寄件者: AI TSANG <[REDACTED]>
寄件日期: 2026年10月05日星期一 14:29
收件者: Adrian Tsz Hin TAM/PLAND
主旨: TKLN 143 response TD and LD and clarification
附件: 143 response to td comment (2).pdf; 143 response to LD comment.pdf

Response to LD comment

Annex 8

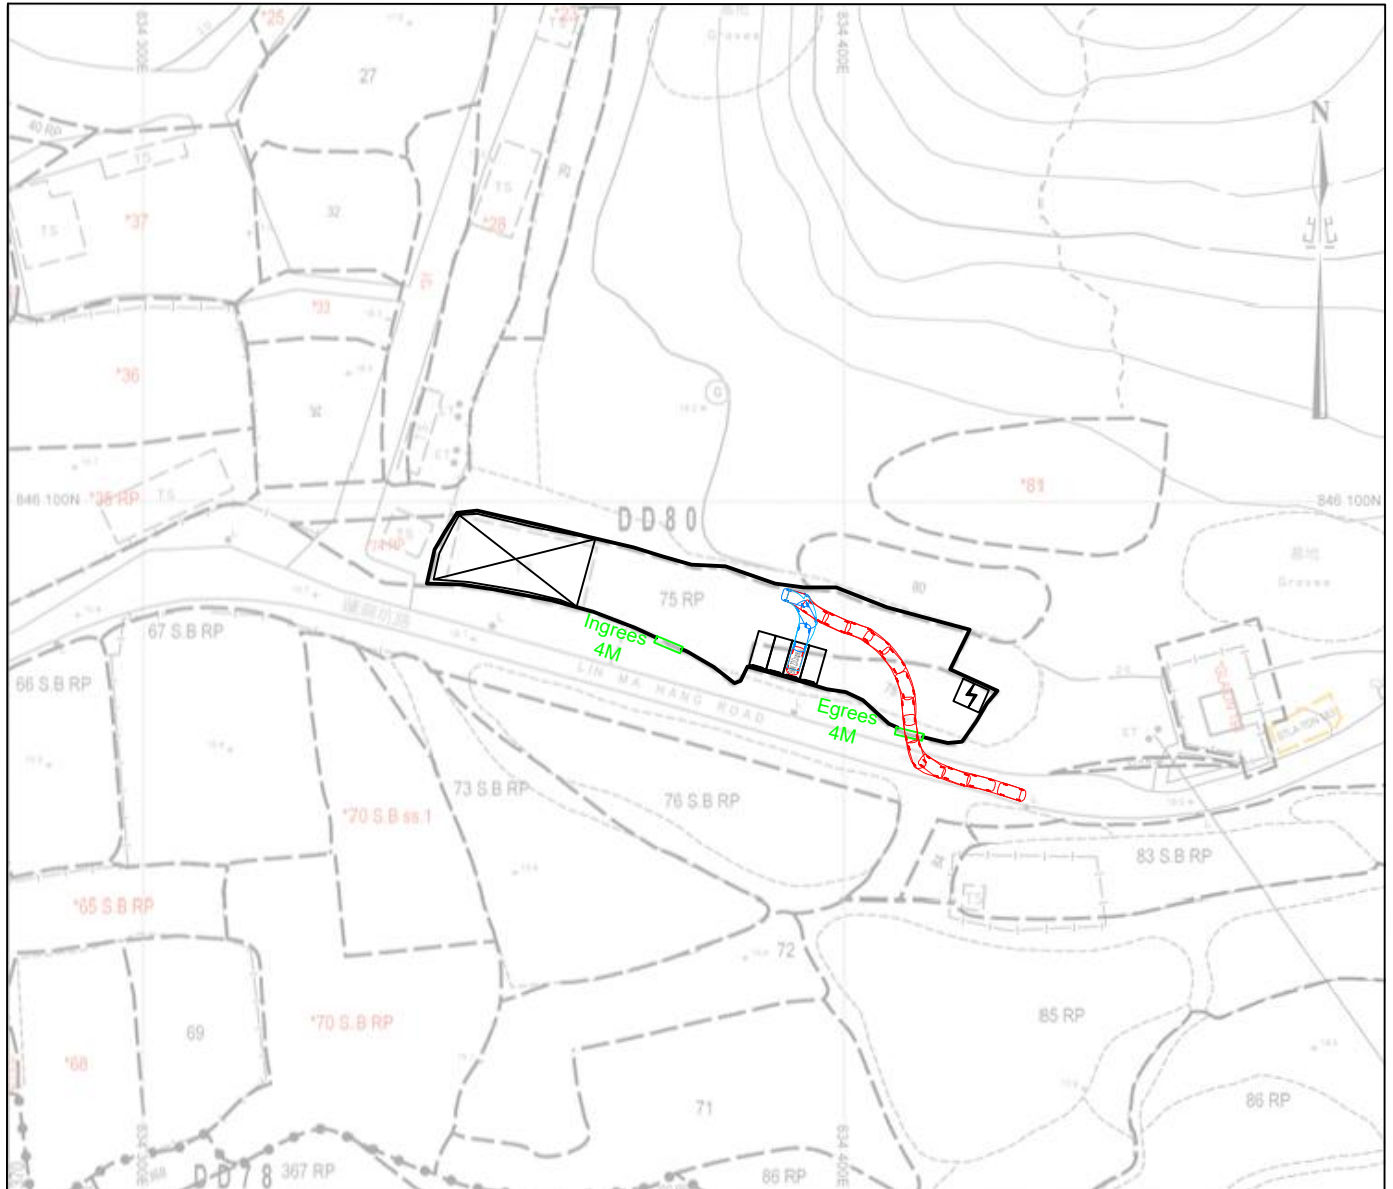
Comment 3
the applicant shall demonstrate the satisfactory maneuvering of the vehicles entering and exiting the application site, maneuvering within the application site and into/out of the parking preferably using the swept path analysis; and
Response
Please refer to swept path plan

- 1.3. The application site has 1 ingress and 1 egress, with a width of 4 meters connecting to Lin Ma Hang Road.
- 1.4. Swept Path Analysis has been conducted for the access points and passages. The site access points and parking arrangements are sufficient for safe maneuvering and operation.
